Access Compliance Report

Public Rights-of-Way

(Curb Ramps)

Intersection ID: 10032864	Main Street: NATIONS_FORD_RD	Cross Street: N/A	Location: W
ADA ID: 3929FECCCAEA	Ramp Type: Para	Initial Pass/Fail: Pass	Overall Compliance: No
Codes/Mitigation Info/Possible Solution		Field Measurements/Component Compliance	
Severity Score: 5

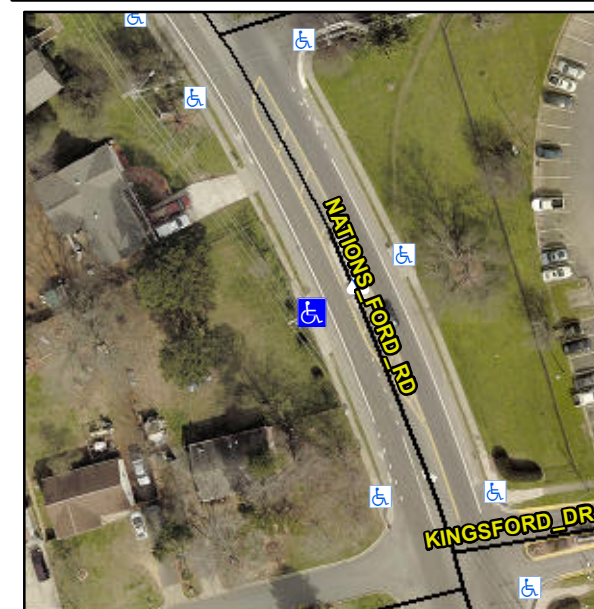
R304.5.4

**Remove & Replace Entire Ramp.
Remove & Replace Gutter.**
